# Building Permit Application

**RE: B14001898  
5103 Honey Locust Court  
Ellicott City, MD 21042**

This letter is in response to building permit B14001898. The application and documents did not include a building permit site plan. Please submit this plan to the Health Department.

SITE DEVELOPMENT & SEDIMENT/EROSION CONTROL PLAN  
**WALNUT CREEK**  
 PHASE TWO  
 LOTS 24 THRU 34 & 44 THRU 47  
 ZONED: RC-DEO AND RC-DEO  
 TAX MAP NO: 28 GRID NO: 17 & 18 PARCEL NO: 49  
 5TH ELECTION DISTRICT HOWARD COUNTY, MARYLAND  
 SCALE: 1" = 30' DATE: SEPTEMBER, 2013  
 SHEET 4 OF 5

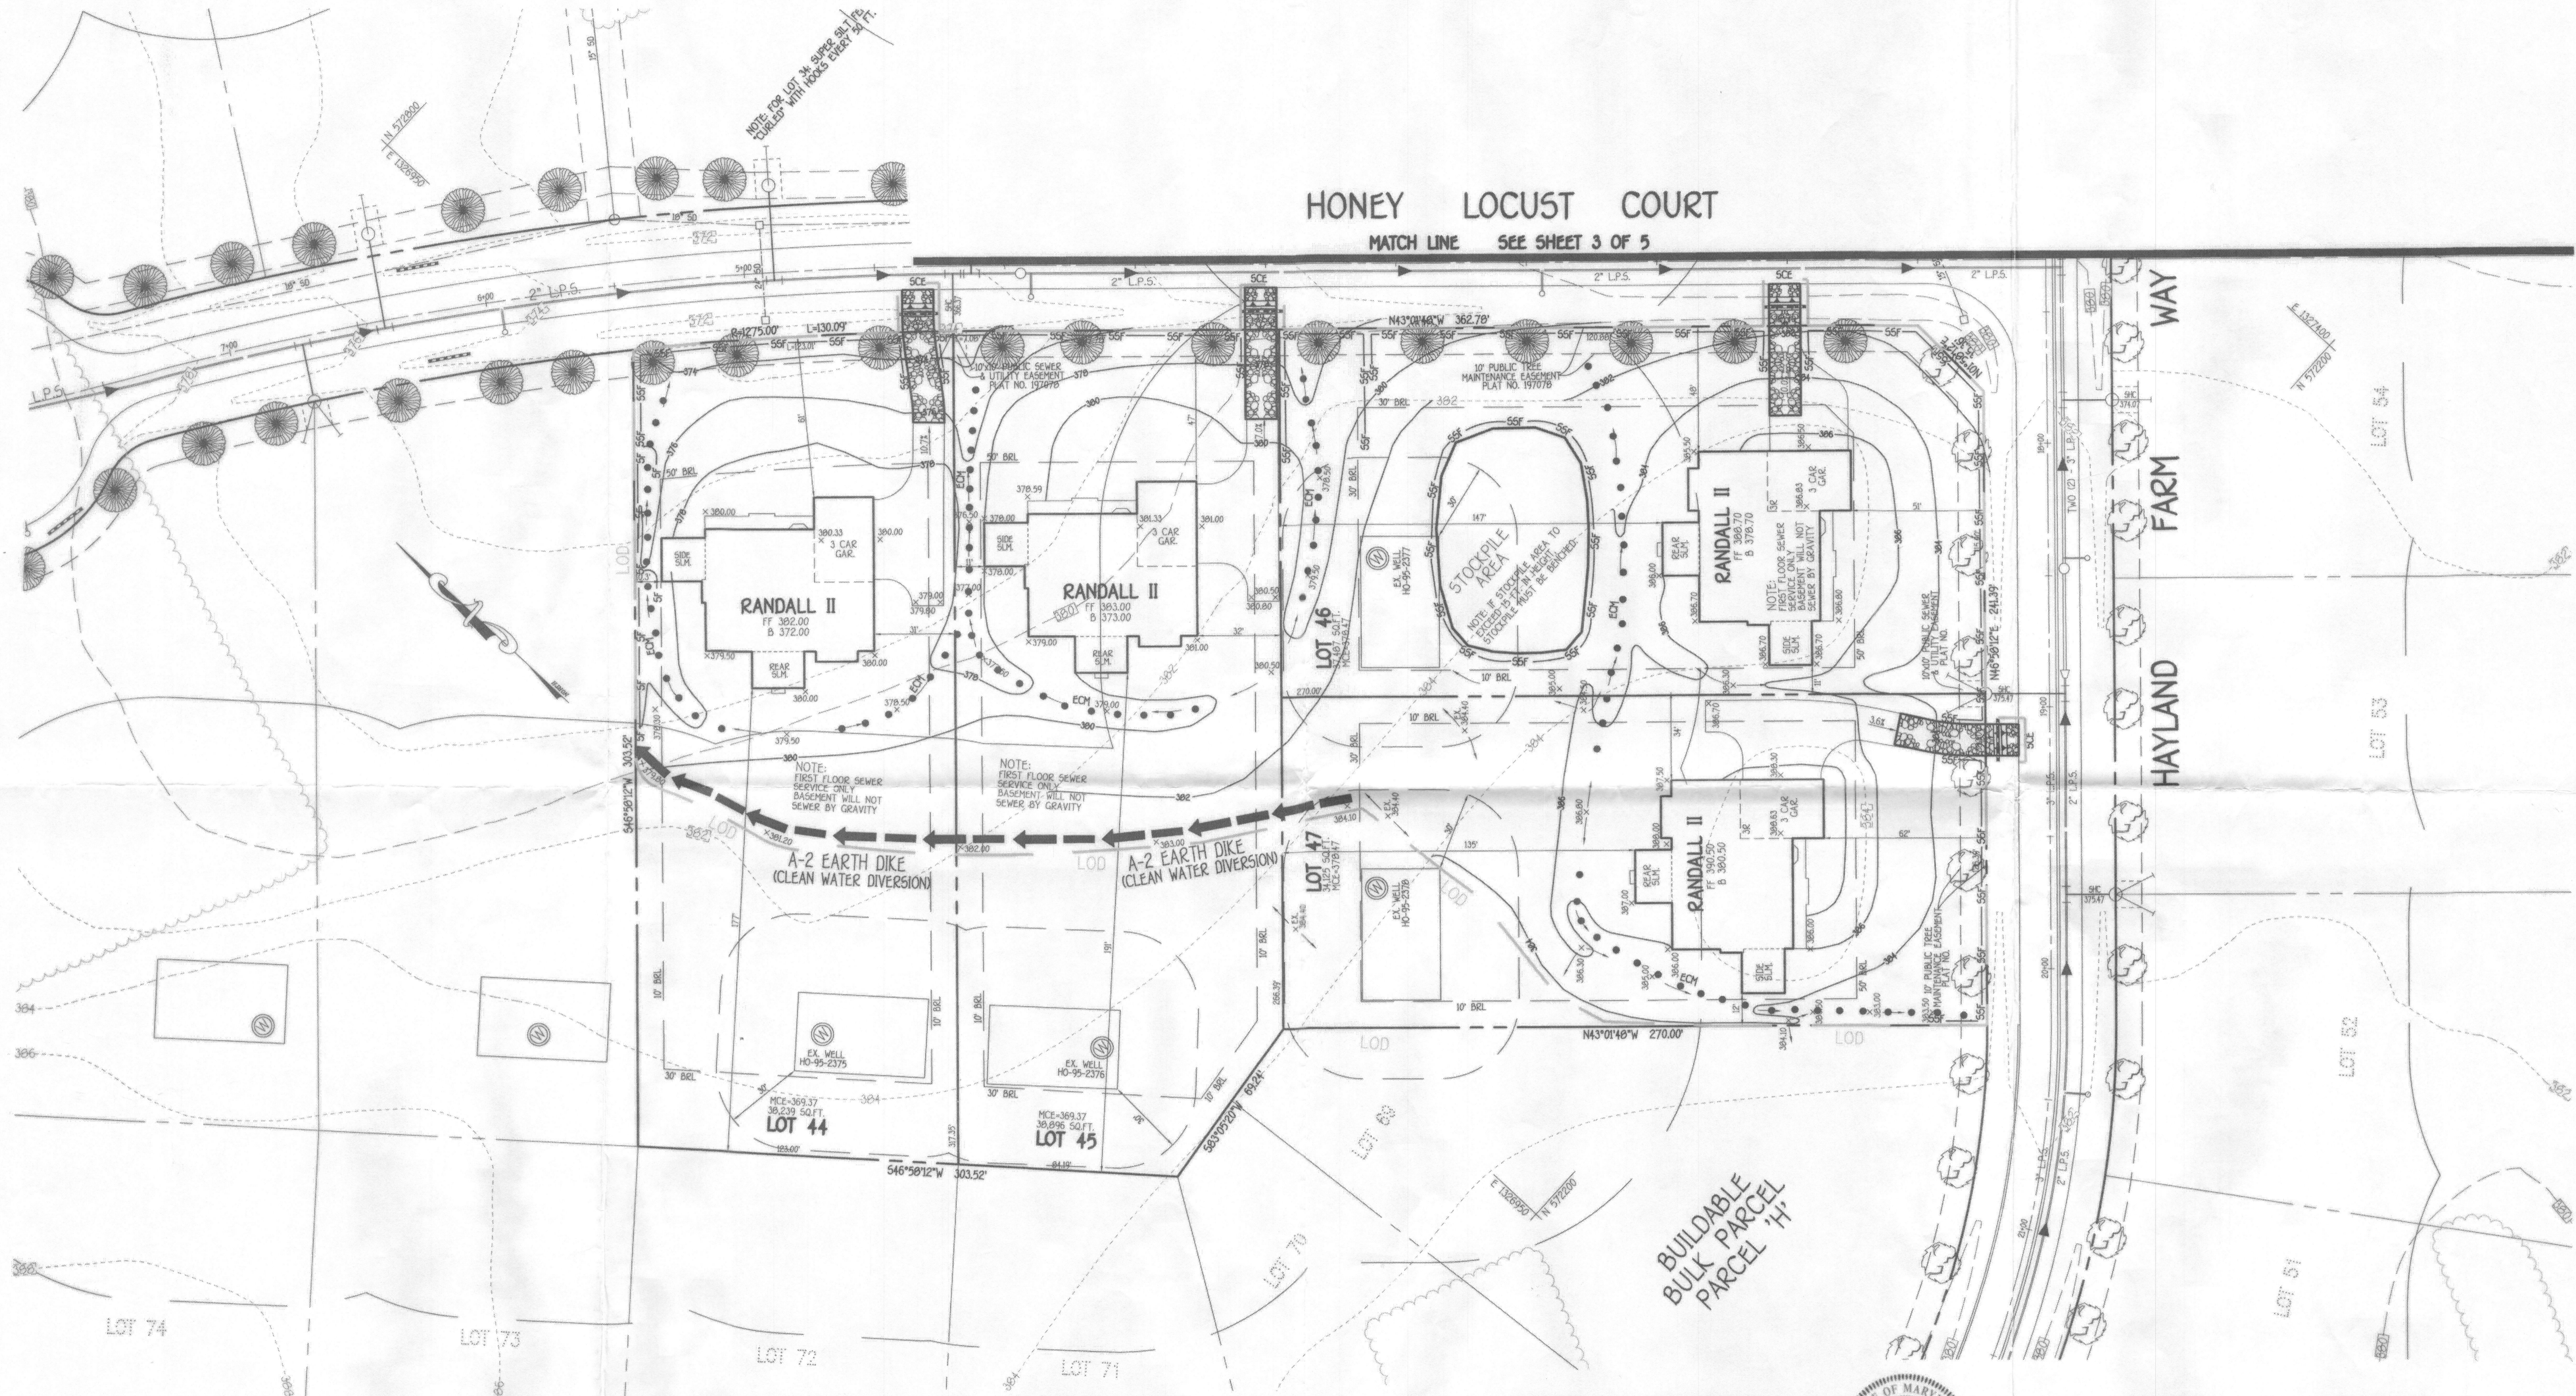
Building permit approval is being withheld until this plan is forwarded to the Health Department. I may be reached at (410) 313-1786 if you would like to discuss the project.

Unfortunately, I am not able to print this to scale. Please forward a scaled copy to the health department for review.

*7/8/14 - spoke w/ Steven Landoll about  
LaToya Tilghman's site plan invert detail, f  
floor plans w/ correct model name :- H.O.*
